Thoughts on NEI Comments on Draft Regulatory Issue Summary (RIS) - Considerations in Licensing High Burnup Spent Fuel (HBF) in Dry Storage And Transportation

May 18, 2015
Public Meeting with NEI

Draft HBF RIS – Background and Status

“Transportation Flowchart” cont.

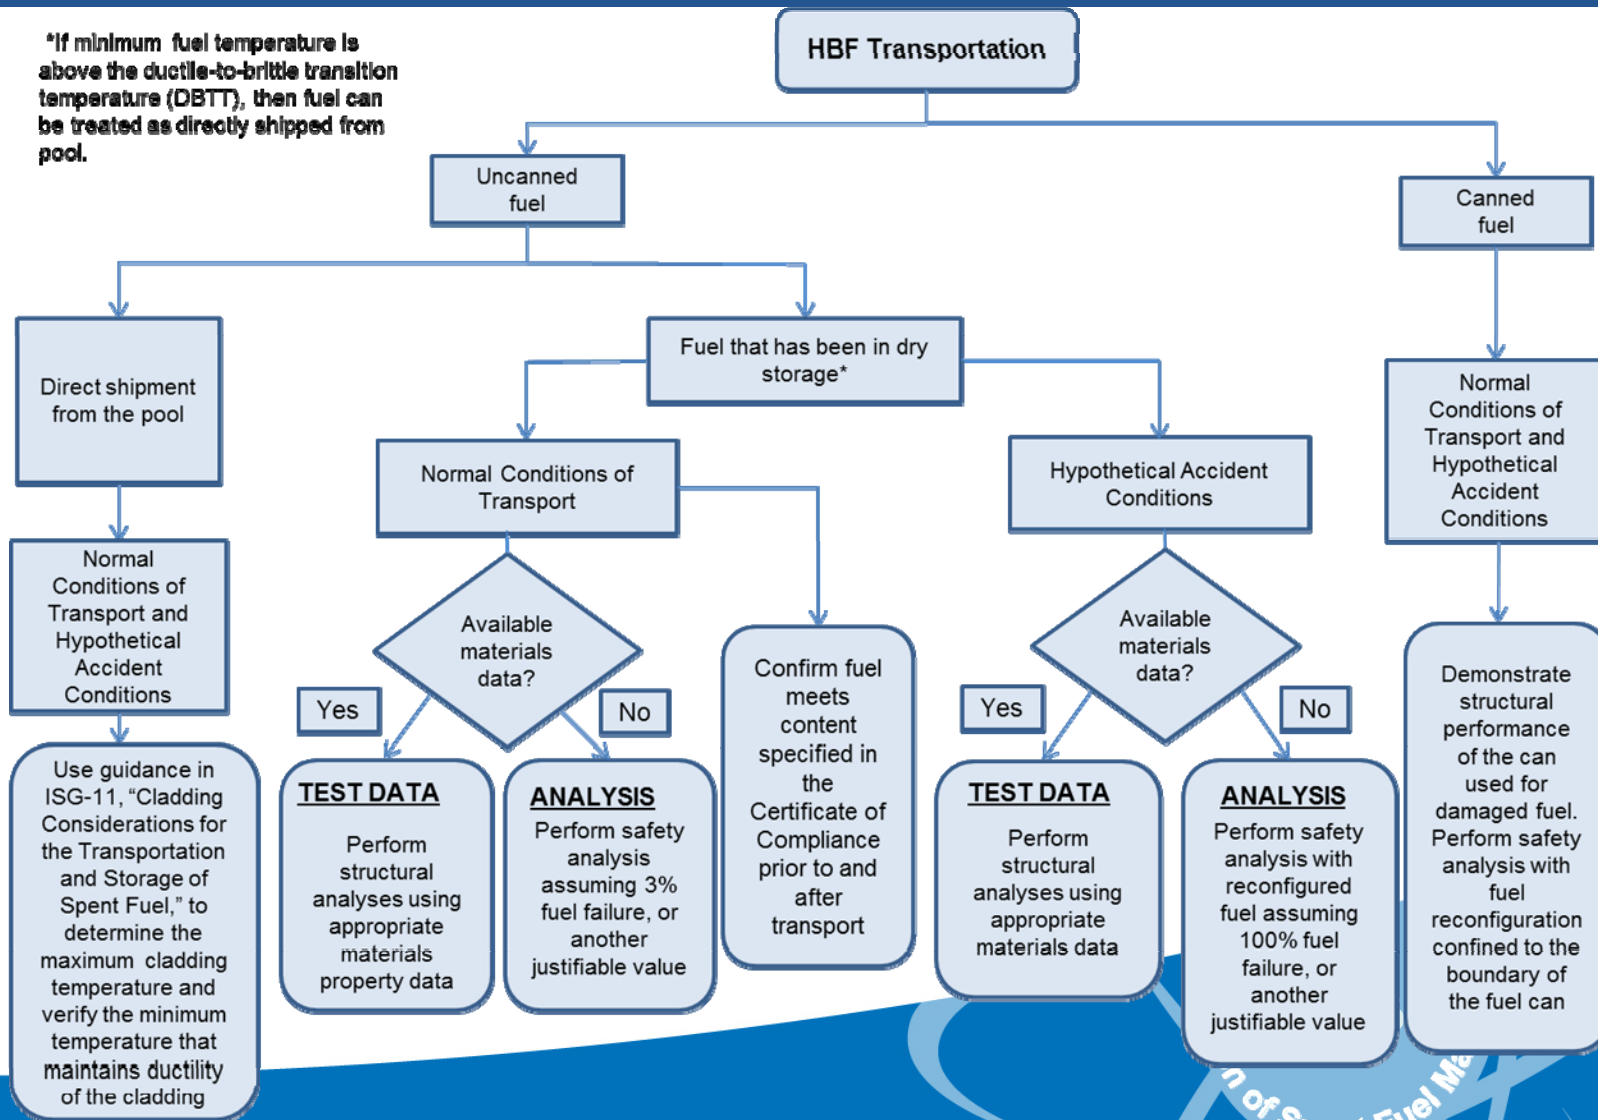
- Table Comment #2, Part 2 and Table Comment #14
- Why are different paths established for fuel directly shipped from the pool and fuel that has been in dry storage?
- This should be revised based on whether the fuel temperature is above or below the DBTT at the time of shipment
- Concept of hydride reorientation and DBTT is explicitly stated in flowchart (asterisk)
- Already have application using approach from the spent fuel pool
- Keeping statement as-is

- Concept of hydride reorientation and DBTT is explicitly stated in flowchart (asterisk)
- Already have application using approach from the spent fuel pool
- Keeping statement as-is
